DESIGN #	DRAWN BY #	DART AEROSPACE LTD HAWKESBURY, ONTARIO, CANADA	
CHECKED #	APPROVED #	DRAWING NO. DSI 9308	REV. A SHEET 1 OF 1
DATE 05.08.22		TITLE KWIK FLOAT ADAPTER	SCALE NTS
A	05.08.22	NEW ISSUE

DART SERVICE INSTRUCTION

TO AMEND BHA/DRA/358-07-02 REV. F

AND IIN-D206-590 REV. A

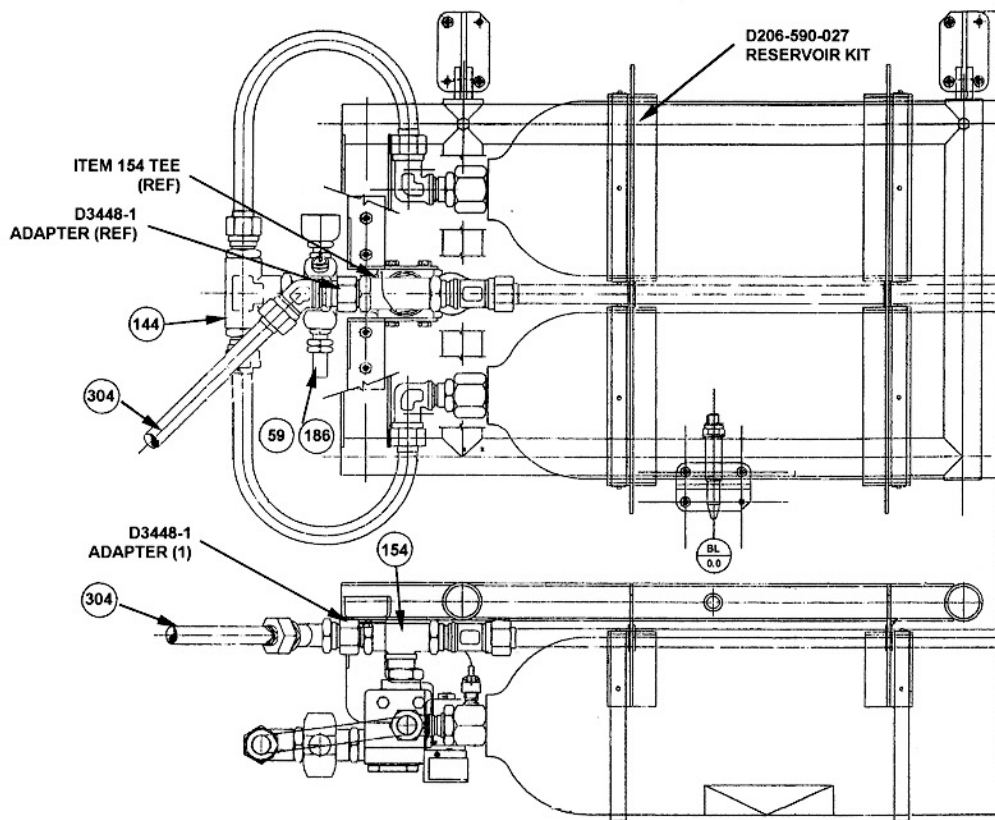
ON D206-590-027 RESERVOIR KIT, IT IS ACCEPTABLE TO INSTALL A D3448-1 ADAPTER BETWEEN THE ITEM 304 HOSE ASSEMBLY AND THE ITEM 154 TEE AS SHOWN BELLOW TO BETTER FACILITATE THE 180 DAY INSPECTION.

- 1) DISCONNECT ITEM 304 HOSE ASSEMBLY FROM ITEM 154 TEE FITTING.
- 2) INSTALL D3448-1 ADAPTER TO ITEM 154 TEE.
- 3) CONNECT ITEM 304 HOSE ASSEMBLY TO D3448-1 ADAPTER.
